We would like to thank reviewer #1 for the positive assessment, constructive criticism and helpful comments. Below we reply to the raised issues point by point, where the comments from the reviewer are typed italic.

This is a nice manuscript that describes an initial attempt to estimate NO_x emissions from 100s of point sources around the globe using TROPOMI NO₂. It is well-written and includes a lot the detailed information necessary for replication. Some minor comments are below. The three more major comments have an asterisk in front of them.

Fig. R1: ZOOMS of the divergence map around (+/- 50 km) the top ten emitters of the USA. This figure is added to the revised Supplement.

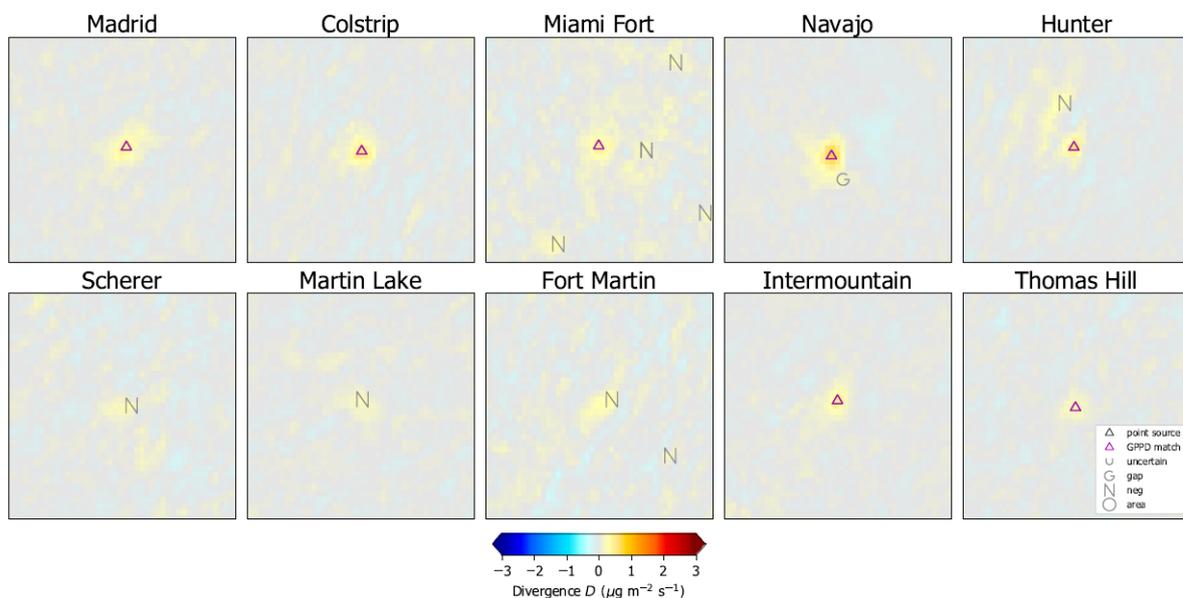
*Page 21 Line 25. I understand that accurate quantification isn’t necessarily the goal here, but it’s still important to compare to reported NOx emission data. In the United States, at least, annual NOx emissions data from top power plants is very easy to acquire. To download annual data visit this website: <https://ampd.epa.gov/ampd/>, scroll down to “Get Reports” on bottom right and click “Start”, on next page click “Top Emitters”, then choose Annual NOx emissions for 2018 (and 2019) by Facility for the top 50 emitters. Seems like European data is here: <https://www.eea.europa.eu/data-and-maps/data/industrial-reporting-under-the-industrial-2> I recommend including a discussion in this section comparing your reported values to the values reported by the US and European agencies.

Following the reviewer’s proposal, we have checked the 10 top emitters for the USA in 2019. 7 out of these 10 power plants are listed in the point source catalog, with correct naming derived from the merging of GPPD information. For the 3 missing plants, also a peak in the divergence map is visible, but the automated algorithm classified these all as “negative”, i.e. a large negative divergence is observed around the plants. As explained in section 3.8.1, this might indicate high noise levels of D or systematic artefacts which might be caused by biased wind fields. Thus, these cases are excluded within the automatized point source identification.

When comparing the emissions, however, we find quite large discrepancies:

For Navajo, which yields the most obvious signal in the divergence map, and is #153 emitter of the global catalog (#3 of North America), the EPA emissions are higher by a factor of 3, which is well in the range of the expected low bias mainly due to missing AMF and lifetime correction.

For the other power plants, however, EPA value are higher by factors of 5-8, which is out of the range of uncertainty given in the discussion paper. These power plants, however, are quite remote from large cities. Thus, in absence of other significant NO_x sources, the modelled profiles used as a-priori for the calculation of AMFs do not reflect the near-surface power plant plume due to the coarse model resolution.

In addition, the cloud altitude used for the calculation of averaging kernels is biased low (Compernelle et al., 2021), causing high biased AMFs and low biased columns. The impact of this bias can easily reach one order of magnitude for cases where the retrieval assumes a cloud below the plume, while it is actually above.

For these reasons, we have to expect that the low bias of the partial column added by a point source close to the ground is considerably larger than that of the complete tropospheric column, where validation studies report typical low biases of a factor of 2 for polluted sites.
